CITY OF ALBUQUERQUE TRANSPORTATION
DEPARTMENT REVIEW COMMENTS
7/11/2016
RBA ARCHITECTURE RESPONSE TO COMMENTS 7/12/2016

TUYET SON BUDDHIST TEMPLE
ARCHITECTURAL - SITE PLAN BLDG. A
ALBUQUERQUE, NM
PROJECT #1580

TCL-1

1 ARCHITECTURAL - SITE PLAN
1"=20'-0"

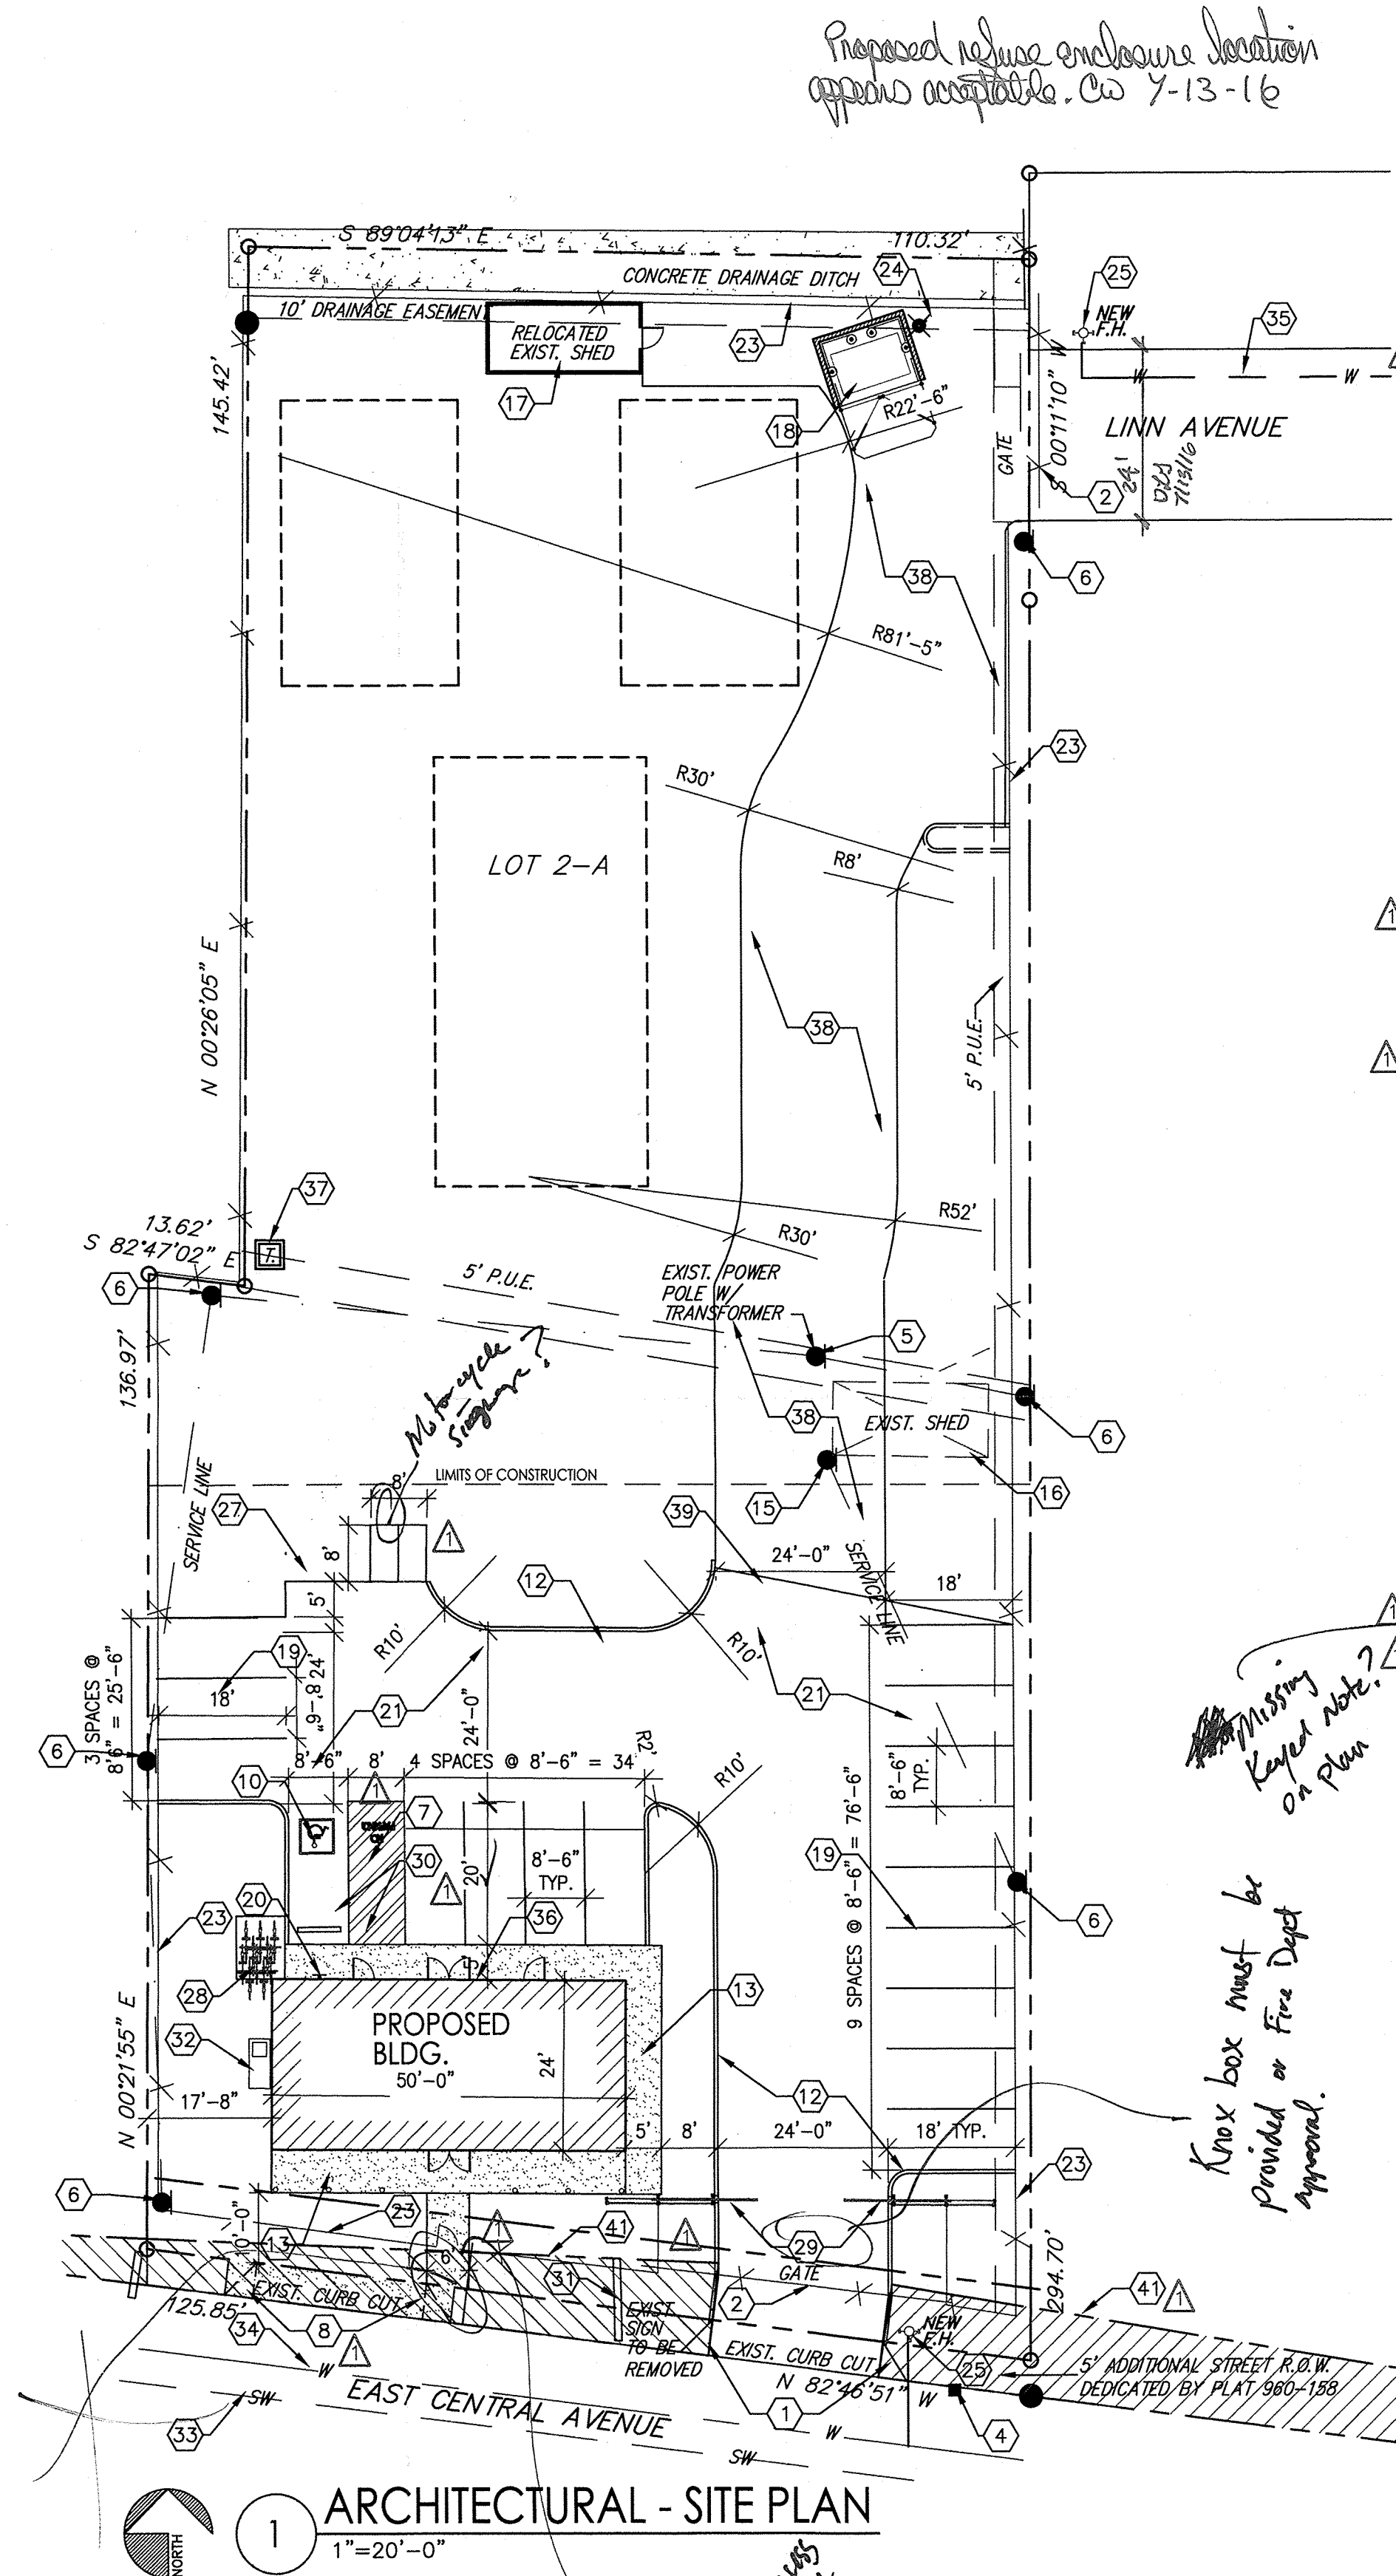
1. The handicap accessible spaces must be a minimum of 20 ft. in length.
Response: Has been modified to 20' length.
2. The handicap accessible spaces must include an 8 ft. access aisle; all other aisles should be 5 ft. in width.

Response: Aisle has been modified to be 8 ft in width.
3. The ADA accessible parking sign must have the required language per 66-7-352.4C NMSA 1978 "Violators Are Subject to a Fine and/or Towing." Please call out detail and location of HC Signs.

4. We recommend that the motorcycle parking be moved to the East end of the 5 foot key way.
COA Response: Add with motorcycle signage to keyed note 27.
Response: Motorcycle parking spaces have been relocated as directed.

5. Per DPM, a 6 ft wide ADA accessible pedestrian pathway is required from the public sidewalk to the building entrances. Please provide details.
Response: A standard 4" thick 6' wide concrete sidewalk has been provided from the back side of the sidewalk located on Central up to the concrete building sidewalk as indicated on drawing per COA 2430 Paving Sidewalk Details.

6. Service vehicle and/or refuse vehicle maneuvering must be contained on-site; provide a copy of refuse approval.
Response: See Solid Waste sign-off.
7. Please provide a sight distance exhibit for Lomas Blvd. (see the Development Process Manual, Chapter 23, Section 3, Part D.5 Intersection Sight Distance). Response: First, sight is located mid-way on Central Ave just past Juan Tabo intersection not Lomas Blvd. Layout of Figure 3 of Part D.5 will be used for sight layout on this project.

8. Please add the following note to the clear sight triangle: "Landscaping and signage will not interfere with clear sight requirements. Therefore, signs, walls, trees, and shrubbery between 3 and 8 feet tall (as measured from the gutter pan) will not be acceptable in this area.

11. Unused curb cuts must be replaced with sidewalk and curb & gutter. A build note must be provided referring to the appropriate City Standard drawing.

Response: Note has been added as key note 8 referencing COA 2415A, 2430.
COA Response: key not 8 does not reference COA STD DWG 2430. Please correct.
12. All broken or cracked sidewalk must be replaced with sidewalk and curb & gutter. A build note must be provided referring to the appropriate City Standard drawing.

Response: Note has been added to sheet as General Notes, note A.
13. Keyed notes 22 and 26 appear not to be called out in plan.
Response: Notes have been deleted.

1. Keyed notes 3 & 40 are missing from plan, please add.
 2. Provide a Knox Box to the sliding entry gates or approval from the Fire Department.
 3. The pedestrian access gate must remain unlocked during business hours. Add note to plan.

Response: Please note that this was called out on our Handicap Parking Signage detail G/AC-2 Site Details Sheet attached to review package.
COA Response: Reference SIGN TYPE R7-8 (12"x18") see detail and attached 2009 New Mexico Accessible Parking Checklist page 3 of 6 "Parking Lot Sign".

Response: Note has been added to drawings, key note 41.
9. Please specify the City Standard Drawing Number when applicable
Response: Will be noted as required.

10. Please add a note on the plan stating "All improvements located in the Right of Way must be constructed through the COA DRC work order process.
Response: Note has been added to drawing as General Note B.
